City Planning Commission Meeting – February 10, 2015

CONSIDERATION – SUBDIVISION DOCKET – 178-14

Applicant: Full Circle Homes LLC

Proposal: Re-Subdivision of Lot 9-A into Lots 9B and 9C.

Figure 1: Applicant's Original Subdivision Survey

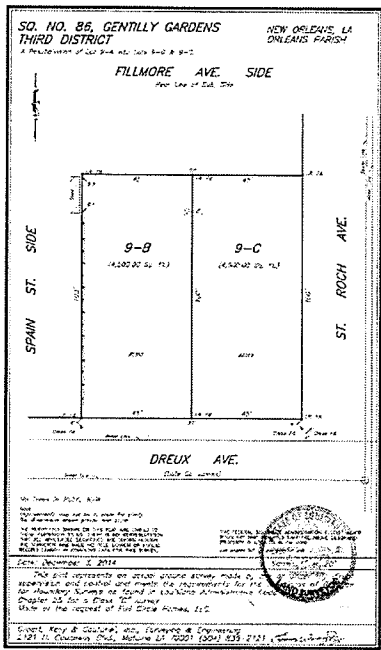
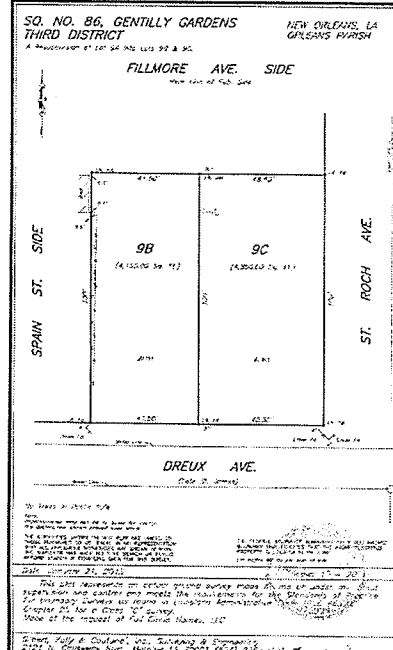
As of the writing of this report, the staff had received responses from the Department of Property Management's Division of Real Estate and Records and the Department of Safety and Permits, which both reported no objection to the proposed subdivision. However, the applicant recently submitted an updated survey (see Figures 1 and 2) which the staff has sent out to all of the corresponding departmental agencies. The original survey subdivided proposed Lots 9B and 9C into identical, substandard lots. The applicant's updated survey reduces Lot 9B by 3'6" in width and reallocates this to proposed Lot 9C, so that it will be easier to provide the RS-2 District required 10' corner side yard.¹ The updated survey results in substandard Lots 9B and 9C, therefore this request must still be heard before the City Planning Commission. The Subdivision Regulations permit the City Planning Commission to consider the failure of an agency to respond within thirty (30) days as evidence of its approval of the submitted survey.

The RS-2 Single-Family Residential District requires a minimum lot width of fifty feet (50'), a minimum lot depth of ninety hundred feet (90') and a minimum lot area of (5,000 sq. ft.) for single-family residences. Both of the proposed lots meet the minimum depth requirements. However, proposed Lots 9B and 9C are both deficient in that they do not

meet the required lot width or lot area requirements. As Table 4 indicates, there are instances of neighboring single-family residences which do not meet the minimum required lot width or lot area requirements of this district. Therefore, the approval of this subdivision request and the subsequent construction of a single-family residence on each respective lot will fit in with the existing development pattern and will help restore the historic development pattern of the area.

1. The applicant shall comply with any requirements deemed necessary by the Department of Safety and Permits, the Department of Property Management's Division of Real Estate and Records, Entergy, the Department of Public Works, and Sewerage and Water Board.
2. The applicant shall comply with all other Subdivision Regulations, which includes the submittal of mortgage certificates, a consent letter from the mortgage company (if applicable) and tax certificates for the petitioned site.
3. The applicant shall submit a reproducible copy and two (2) prints and a digital copy of the final resubdivision survey in dwg., dxf, or ESRI compatible file format.
4. The applicant shall secure variances from the Board of Zoning Adjustments for the establishment of Lots 9B and 9C, which would have insufficient lot width and insufficient lot area.
